CHANGE/ERRATA INFORMATION

ISSUE NO: 3 3/89

Title: 9000A-8080
Print Date: June 1981
Rev.- Date: 1-7/81

Figure 1.

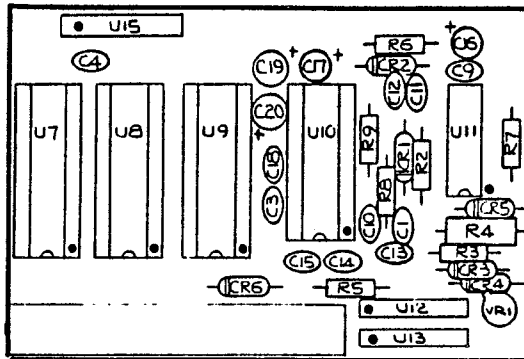
On page 6-11/6-12, Figure 6-3, add CR6 as shown in Figure 1.

On page 6-11/6-12, Figure 6-3, add C19 and C20 as shown in Figure 1.

Figure 2.

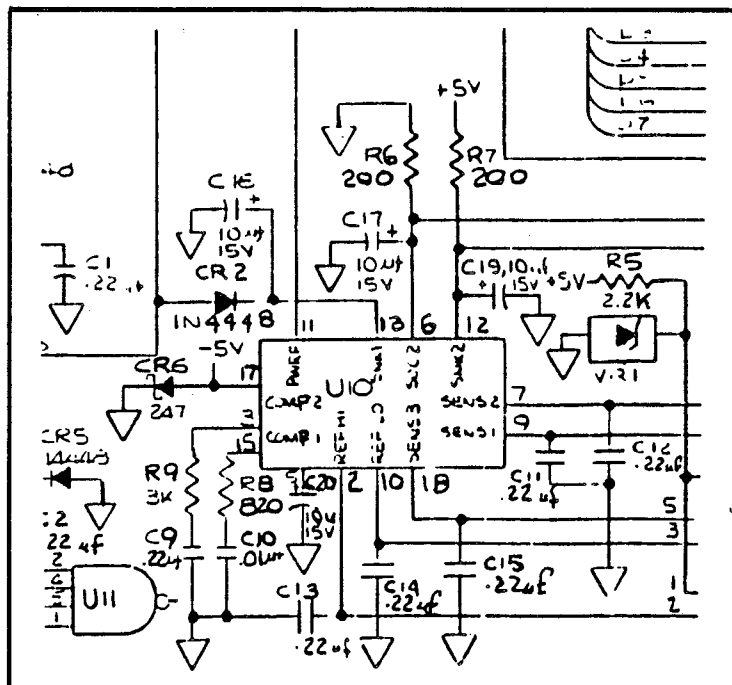
On page 7-4, Figure 7-2, add CR6 as shown in Figure 2.

On page 7-4, Figure 7-2, add C19 and C20 as shown in Figure 2.

Figure 3.

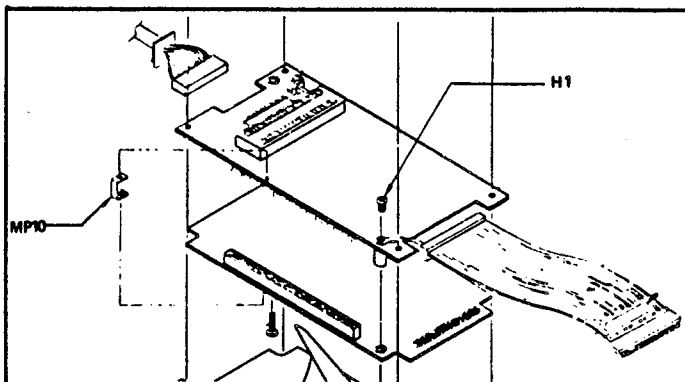
On page 6-4, Figure 6-1, add H1 and MP10 as shown in Figure 3.

Figure 4.

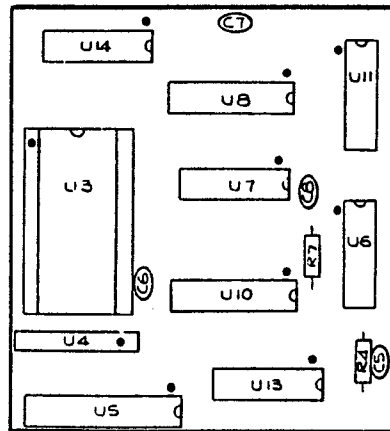
On pages 6-7, Figure 6-2, delete R3 and add R7 as shown in Figure 4.

Figure 5.

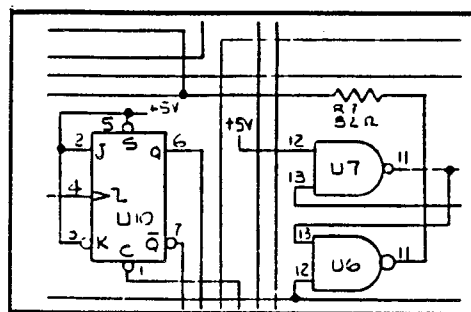
On page 7-2, Figure 7-1, delete R3, change the value of R4 to 39 and add R7 as shown in Figure 5.
